PROJECT: Summerlin West V25 - Scarry Blvd Drive Improvements

SUBMITTAL: 2nd

CITY OF LAS VEGAS		DATE:
INTER-OFFICE MEMORANDUM		May 5, 2021
TO: Land Development Services Department of Building & Safety		FROM: Albert Sung, P.E. Flood Control Project Engineer Department of Public Works
SUBJECT:	Drainage Study for:	COPIES TO:
Summerlin West V25 - Scurry Bend Drive Improvements (from Sunset Run Dr. to Lake Mead Blvd.)		Atkins
Cross Streets:	Scurry Bend Drive. & Lake Mead Boulevard	Howard Hughes Company, LLC
File Number:	F:\Depot\DSMemos\DS5427B.doc	Bart Anderson, P.E., DevCo
Parcel Number:	137-15-801-002 & more	
Zoning Action:	N/A	
FEMA Flood Zone	YES NO X	
Proposed Storm Drain	YES X NO

Summerlin West Village 25

FIGURE 4: HYDRAULICS WORKMAP

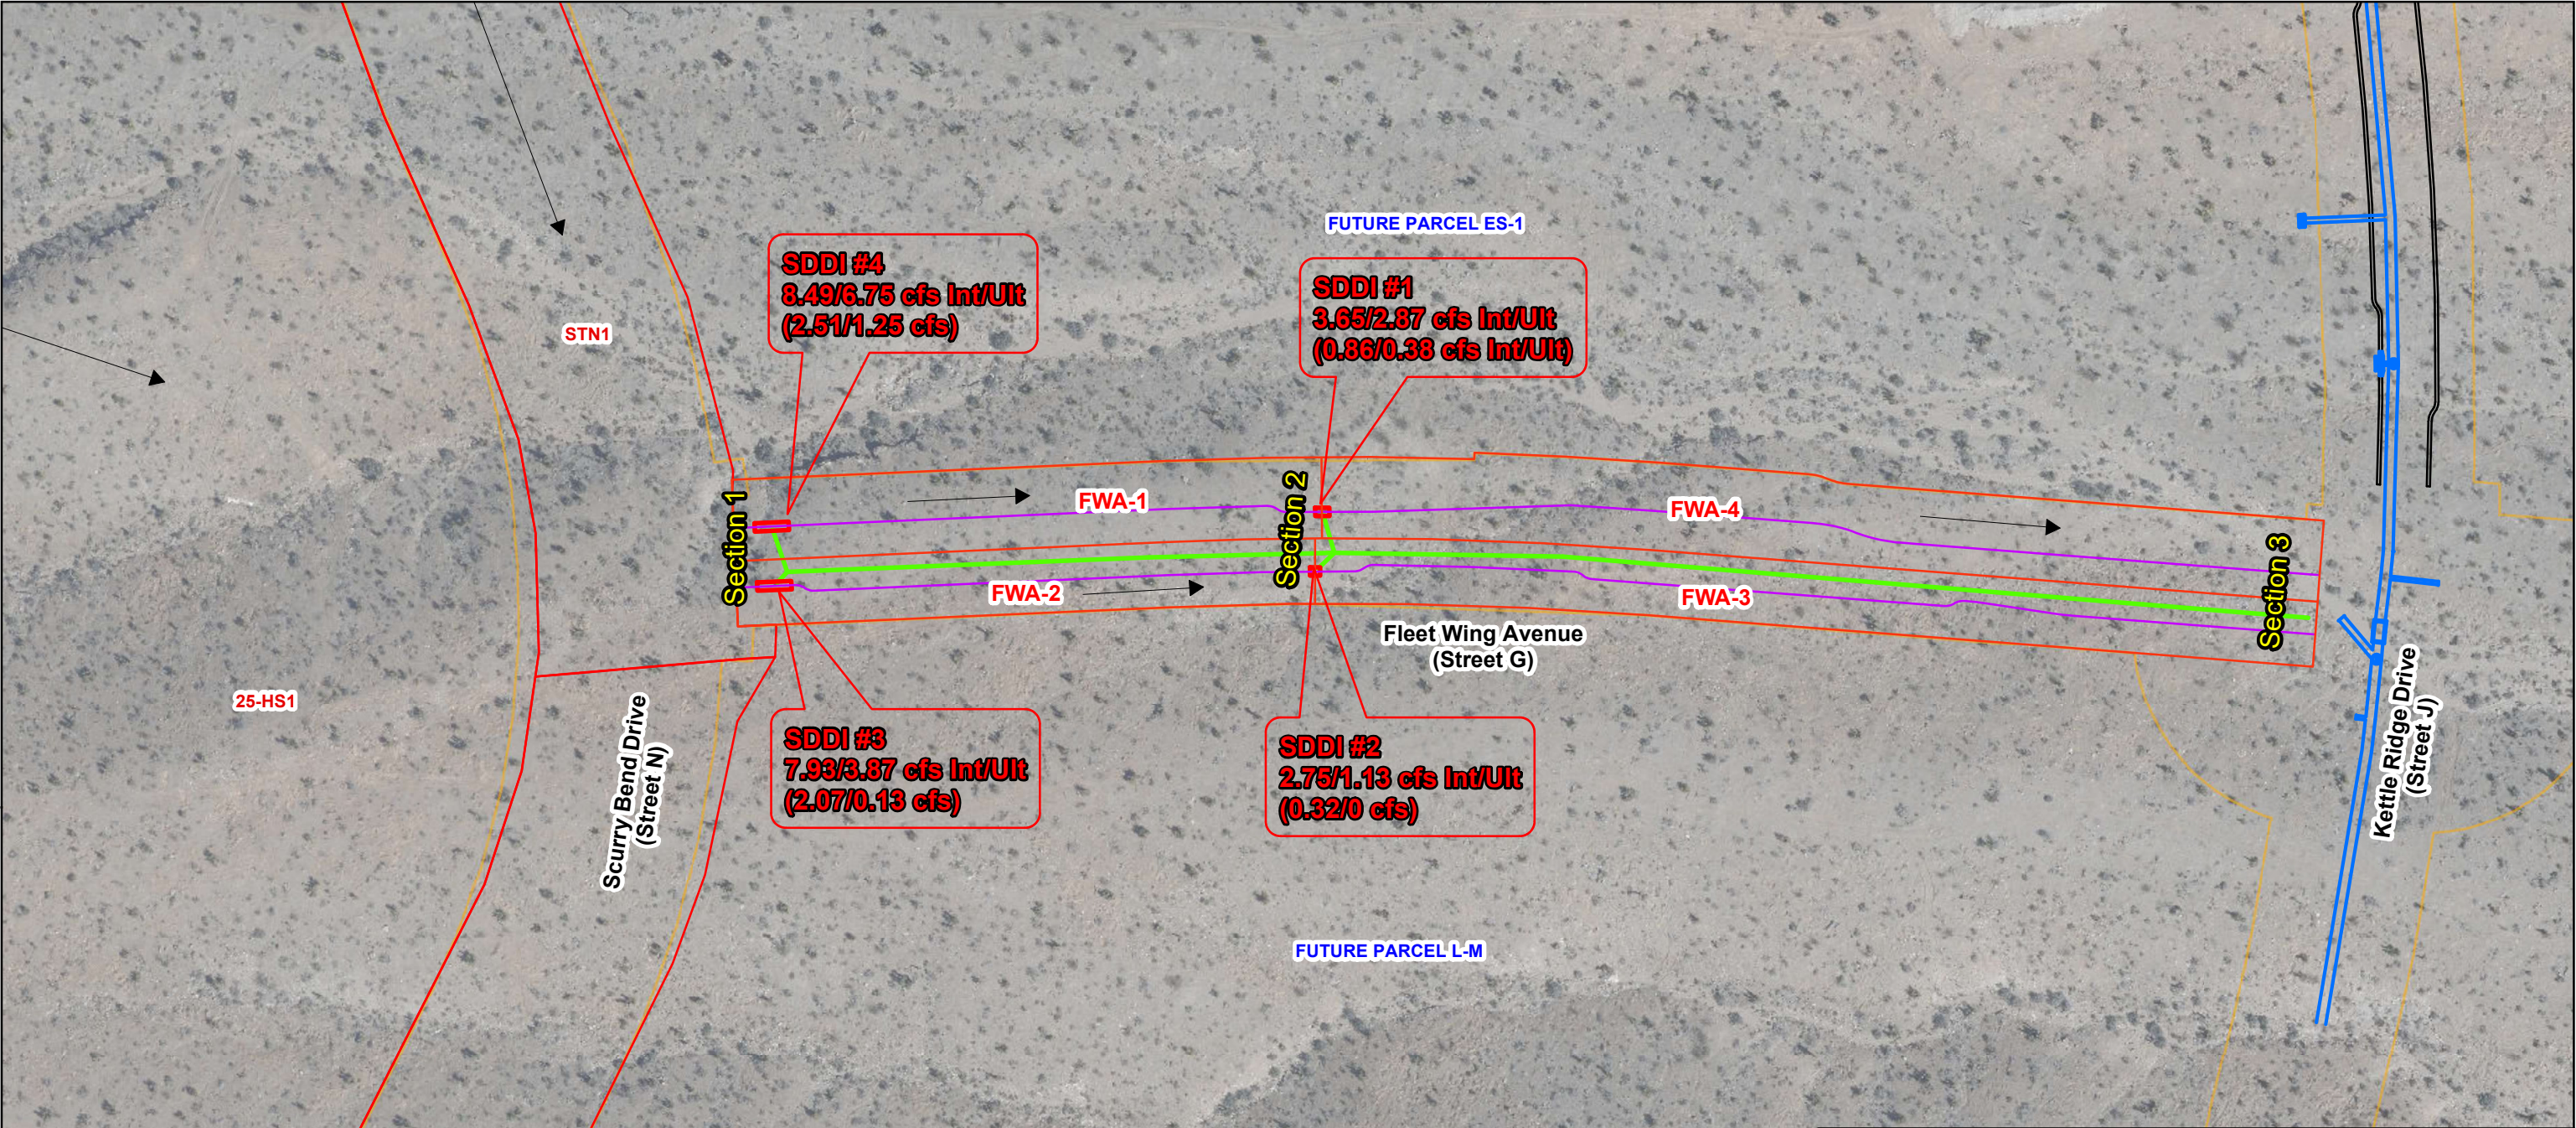
Comment #15: *Sheet 16/42 and Sheet 17/42: The proposed SDDI #4 is at a local low point. Address what is the maximum ponding depth in case the inlet is totally clogged and describe the emergency overflow path in the next submittal.*

Comment response: The FG elevation at the street centerline is 3495.04, the FL elevation of SDDI#4 is 3494.97, resulting in a maximum ponding depth of 0.07 ft (0.8 in) before the flow overtops and flows down Fleet Wing Avenue. Per the approved Technical Drainage Study for Fleet Wing Avenue (Street G): Kettle Ridge Drive to Scurry Bend Drive (DS5367) the drop inlets at the upstream end of Fleet Wing Avenue have been sized to accept the overflow. Figure 4 is provided in Appendix A of this submittal.

FIGURE 3: INTERIM HYDROLOGY WORKMAP

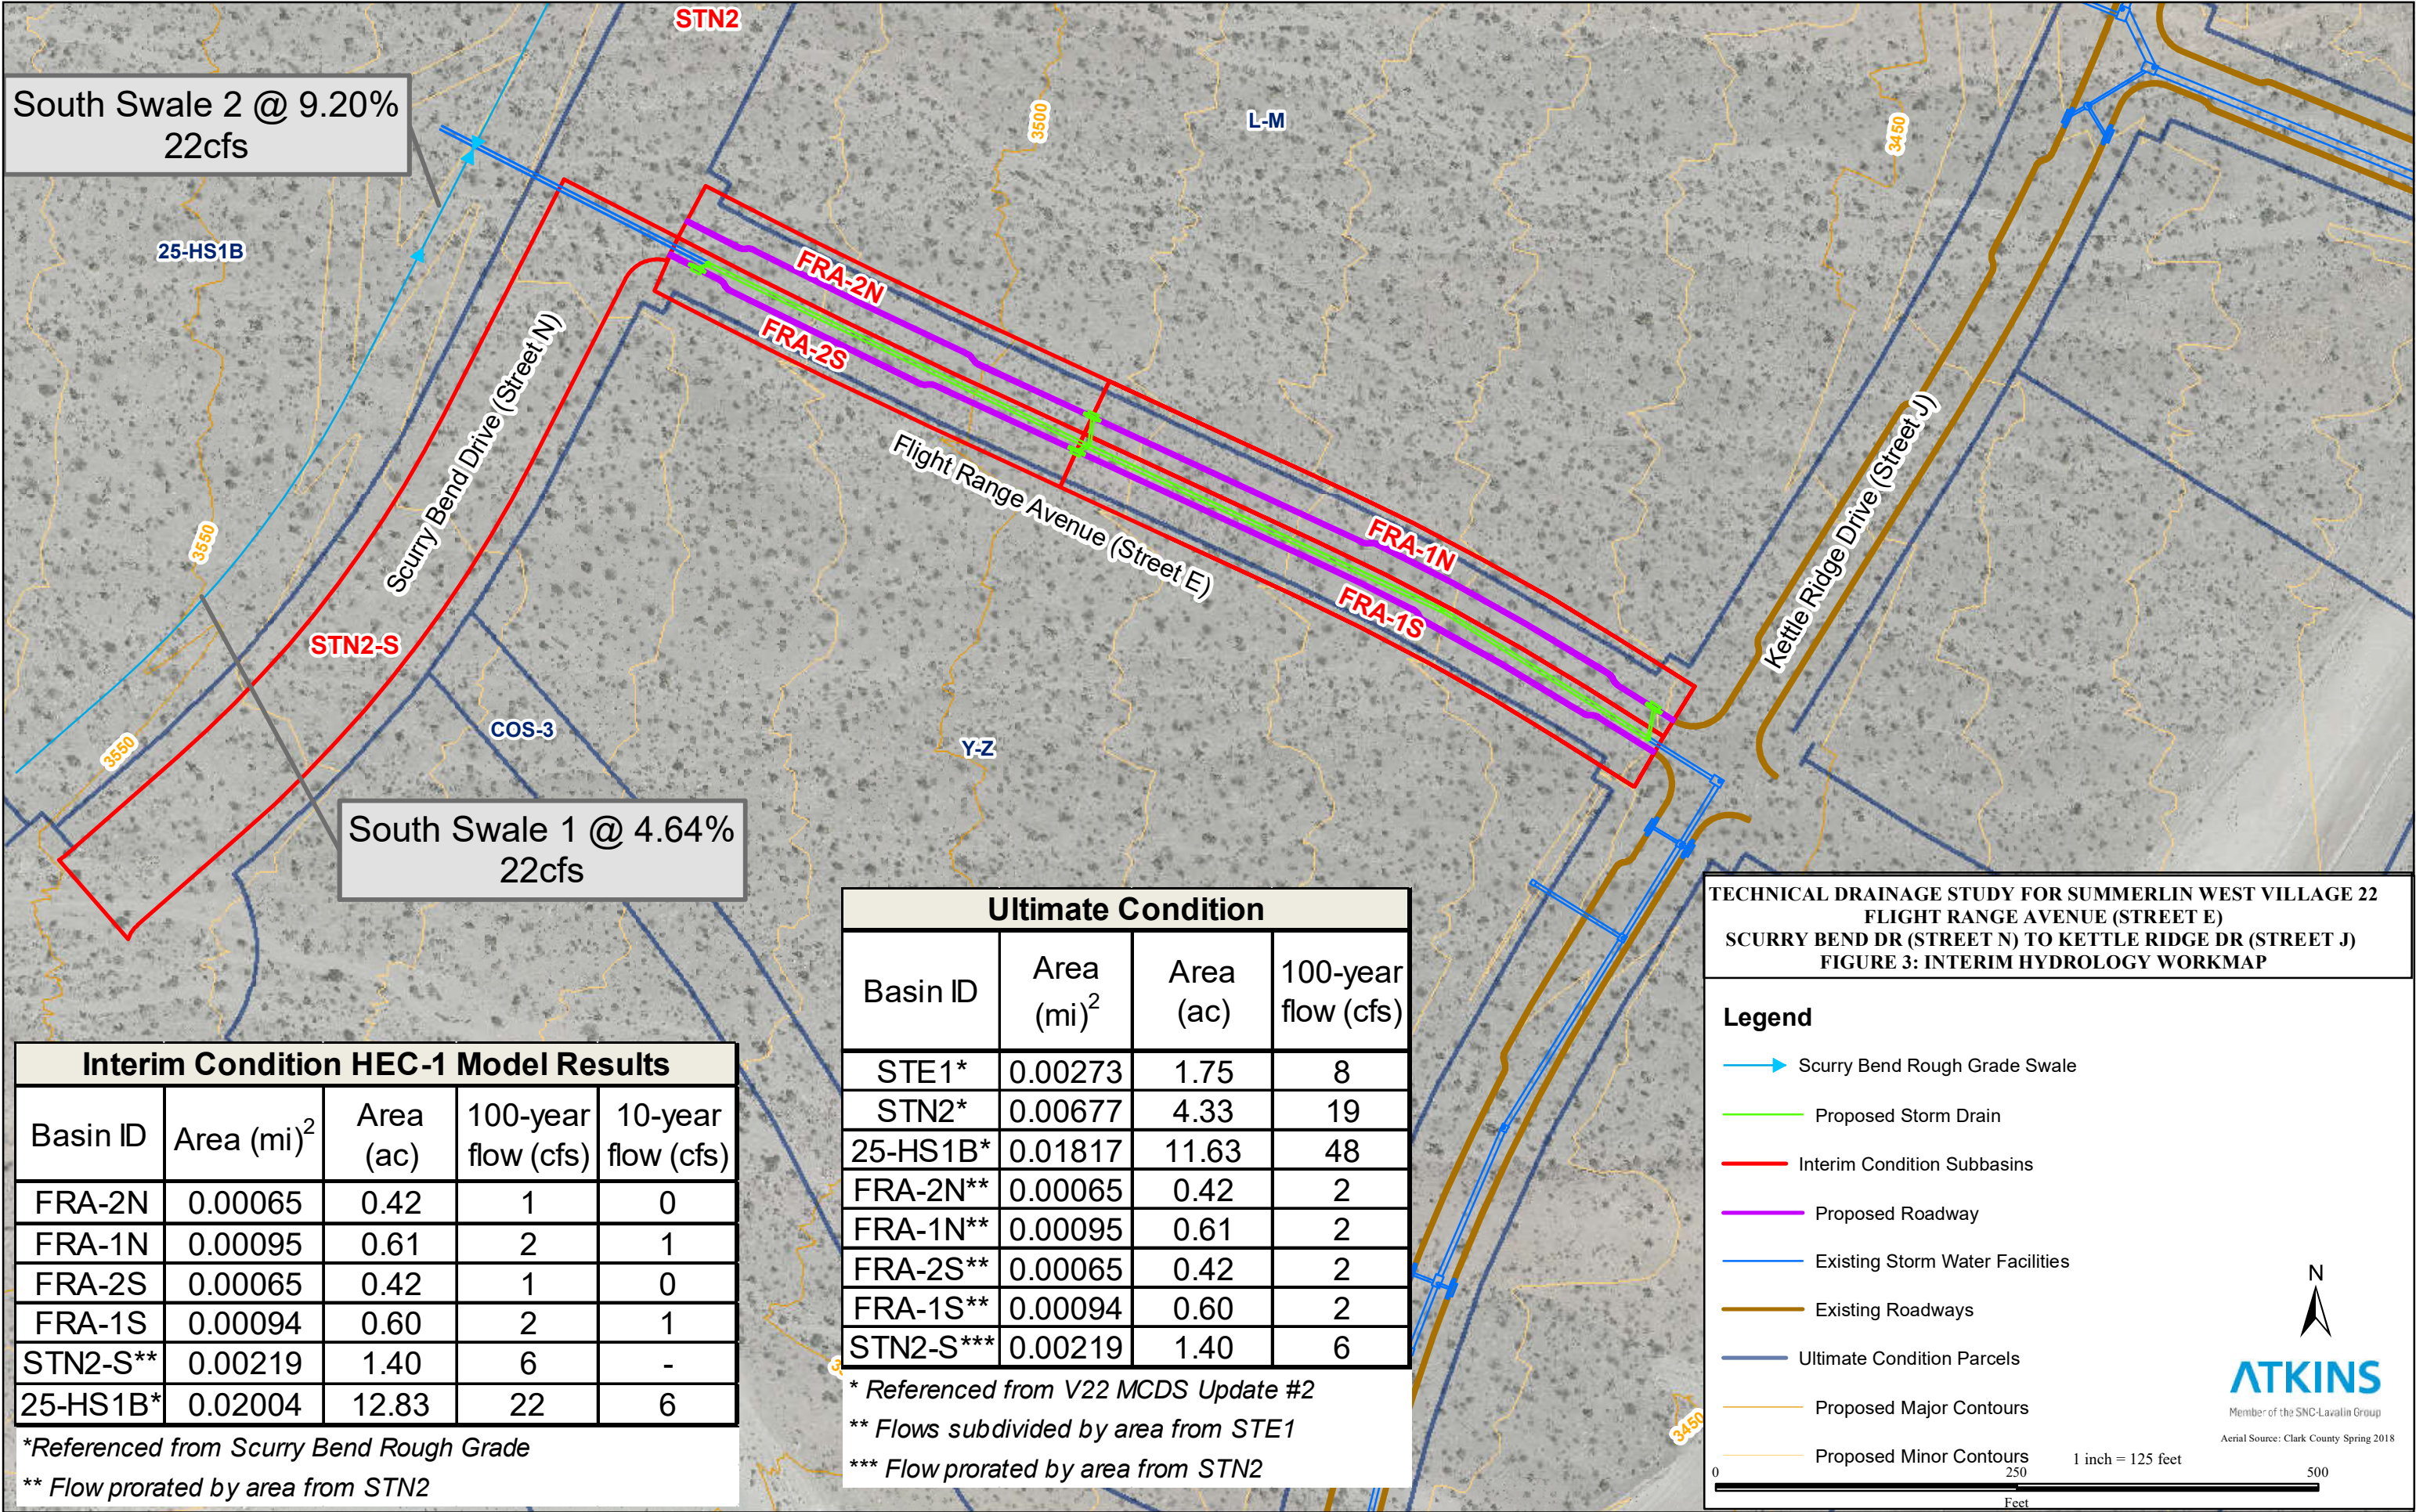
Comment #3: *The ultimate condition hydrology table provided on Figure 3: Interim Hydrology Workmap is unclear. How are these derived? Only a few of them are noted to be reference flows however an ultimate condition HEC-1 is not provided.*

Comment #4: *Provide basin flow arrows for all proposed roadway basins.*

Comment #5: *Show combination points on all the hydrologic condition basin maps.*

Comment response: 25-HS1B and 25-HS1 in the ultimate condition hydrology table are derived from HS-1A and HS-1B found on Figure 6 of Update #1 to the Master Conceptual Drainage Study for Summerlin West Village 25 in Appendix A. The values for Scurry Bend Drive (Street N) subbasins and associated combination points are from the interim model, the other basins remain as modeled in the MCDS Ultimate condition. The summary table on Figure 3 provided in Appendix A has been updated to reflect the proper referenced basins.

Comment response: An updated Figure 3: Interim Hydrology Workmap has been provided.

Comment response: An updated Figure 3: Interim Hydrology Workmap has been provided.
